WHATCOM COUNTY LIBRARY SYSTEM
BIRCH BAY VOGT LIBRARY EXPRESS RENOVATION

ADDENDUM No. ONE (1)

April 28, 2026

1
 A0.10
EXISTING SITE AND DEMOLITION PLAN
 1" = 10'-0"

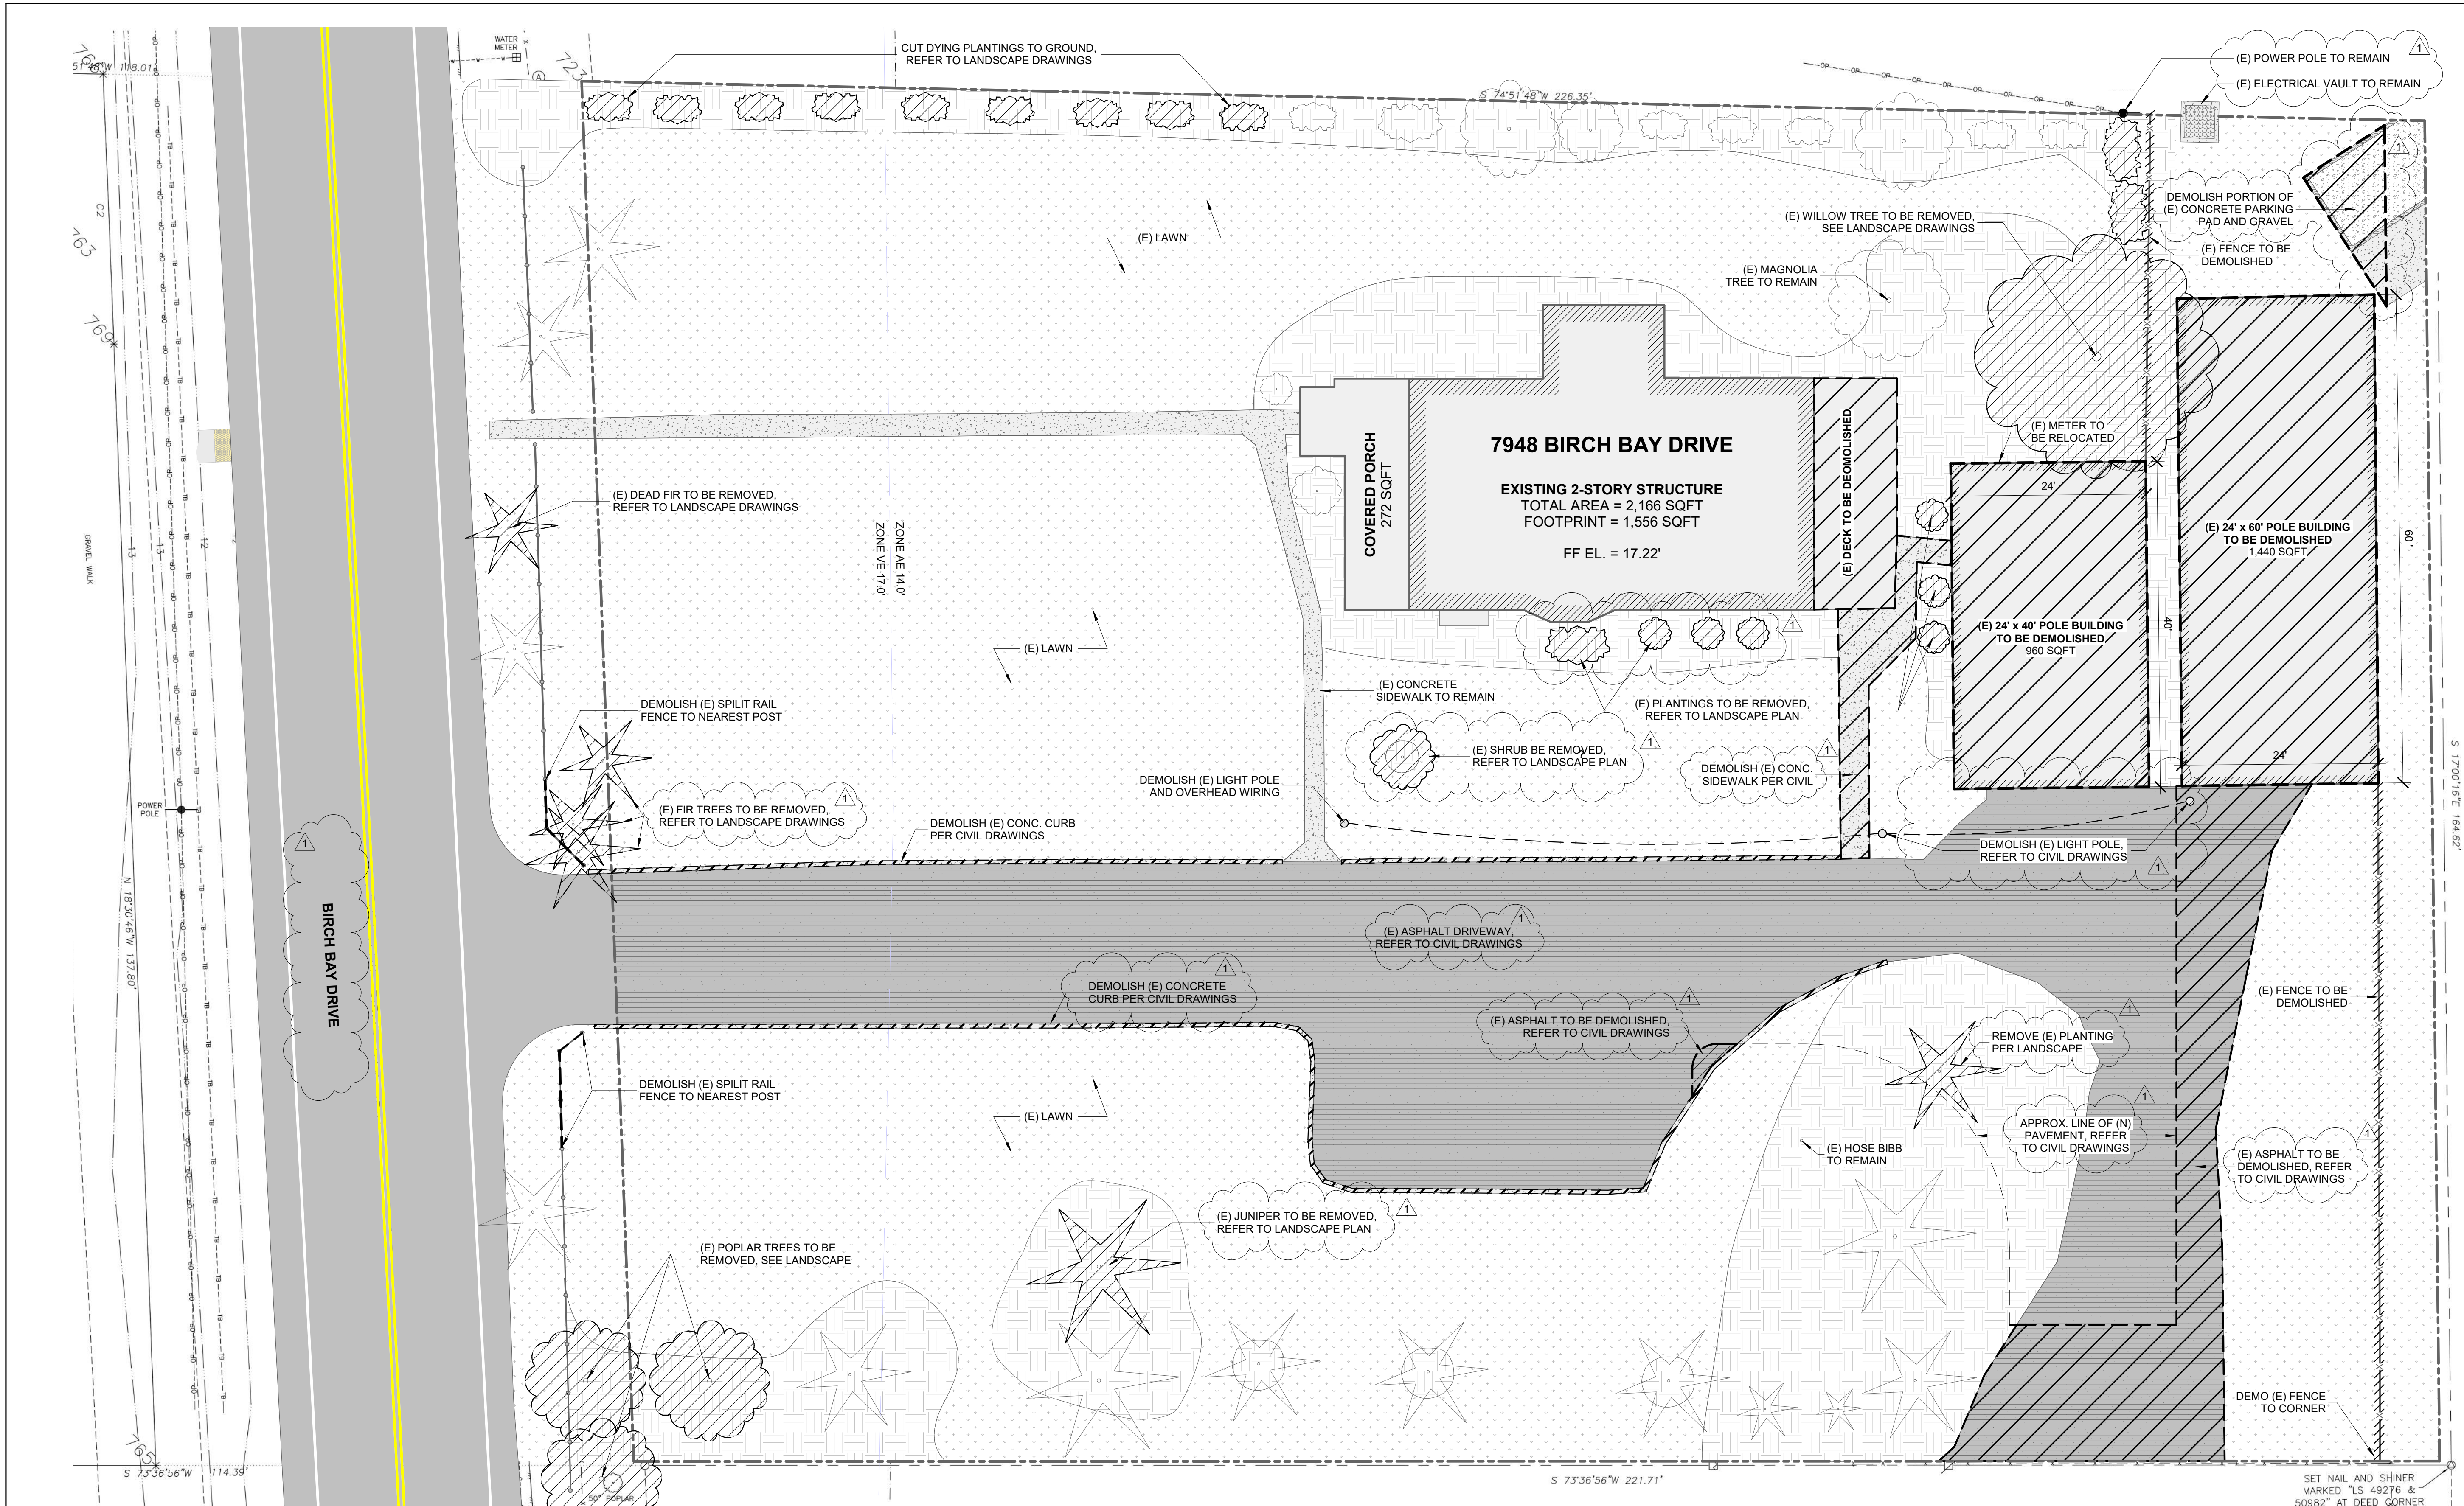
AD 1.1	<p>REPLACE sheet A0.10 – EXISTING SITE AND DEMOLITION PLAN with the copy attached in this addendum. General summary of drawing changes to this sheet include:</p> <ul style="list-style-type: none"> • Encroaching parking pad at the NE corner to be demolished. Refer to ASK-01 for details. • Existing plantings and shrub along the South elevation now shown to be removed for clarity. Refer to the Landscape Plan on sheet L1. • Text notes updated to reference the Landscape, Civil, and Electrical drawings for specific scope of work items. • Updated drawing legend and added general note for archaeological monitoring.
AD1.2	<p>REPLACE sheet A0.11 – ARCHITECTURAL SITE PLAN with the copy attached in this addendum. General summary of drawing changes to this sheet include:</p> <ul style="list-style-type: none"> • Paved surface quantities, easements, setbacks, and other text notes related to permit submittal have been removed for clarity. • Text notes for EV charging have been removed from the parking stalls for clarity. • Planting areas next to the new parking stalls have been added for reference. Refer to the landscape drawings for the complete scope of landscaping work. • Updated drawing legend and added general note for archaeological monitoring

Question 9: "The civil and architectural drawings don't seem to be coordinated on what we're doing with the existing asphalt. On the arch drawing A0.10 we're told the existing asphalt is grind and overlay. On CD101 that area gets pulverized in place which is technically different. Also, there's some asphalt on A0.10 that is shown as being demolished that is not shown on the civil CD101. Does all the demoed asphalt need to remain on site?"

Response 9: Refer to the civil drawings for scope and extent of asphalt work. Sheet A0.10 has been reissued in this addendum for clarity. All demolished asphalt is to remain on site.
